NM1 - ____45____

**GENERAL
CORRESPONDENCE**

**RE: Background Proposal Review
Jay Dan Landfarm, LLC
Permit NM1-045
Location: Unit E of Section 32, Township 15 South, Range 35 East, NMPM
Lea County, New Mexico**

RE: 2014 Bi-Annual Sampling and Five Year Monitoring Report Reviews
Jay Dan Landfarm, LLC
Permit NM1-045
Location: Unit E of Section 32, Township 15 South, Range 35 East, NMPM
Lea County, New Mexico

Jay Dan Landfarm Facility Map

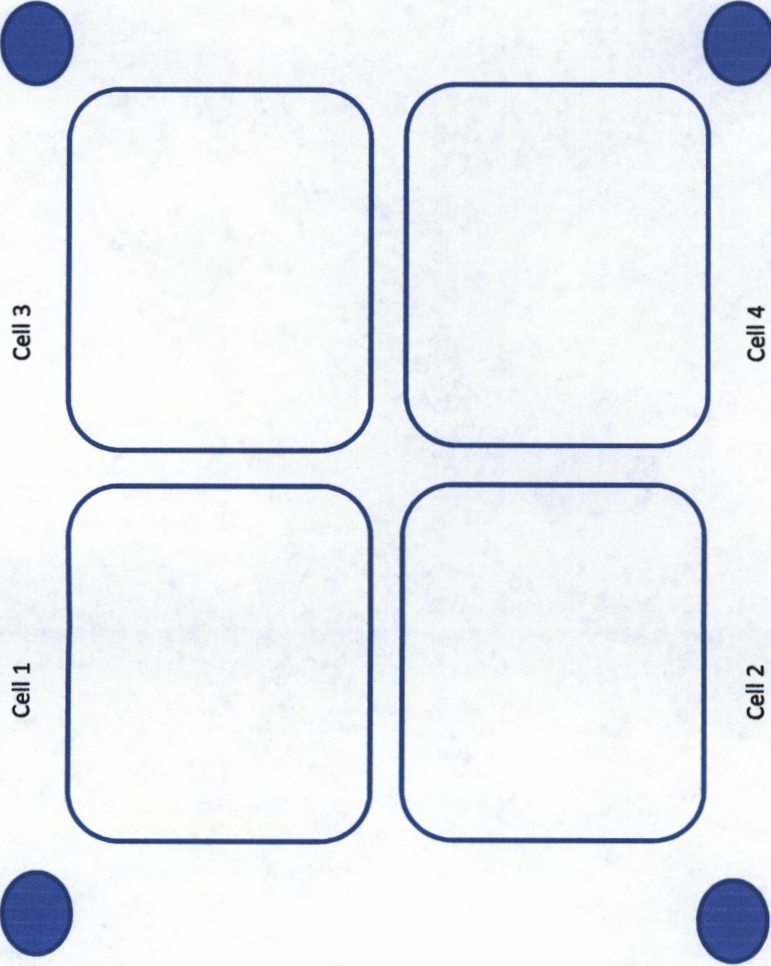
Also, please provided a print out of the most recent Google Earth satellite image of the landfarm facility. Please mark on a printed Google Earth satellite image and identified the proposed background sample point locations and the landfarm cells.

2. The background sampling will consist of four separate locations, NE, SE, NW, SW corners of the landfarm area to make one composite sample. The samples will be taken from areas that have been un-impacted from previous landfarm operations or activities. These samples shall be collected at a depth of two feet.
